RE: Noncompliance Information Report

Model	XG, SONATA(EF), ELANTRA(XD), TIBURON(GK)
Group	FUEL SYSTEM (31)
Number	4-31-P04-XG, EF, XD, GK
Date	FEB. 10, 2004
Area	Guam, Saipan, P/Rico, A/Samoa

FUEL CUT VALVE INSTALLATION (RECALL)

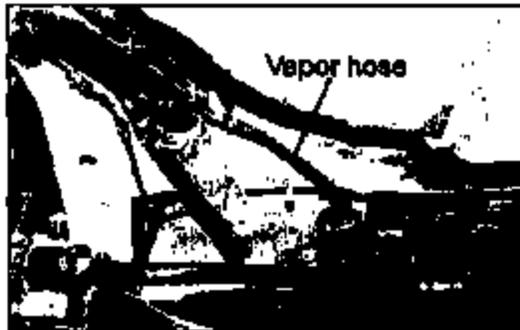
- 3) Remove the rear suspension mounting bolts and lower the suspension.
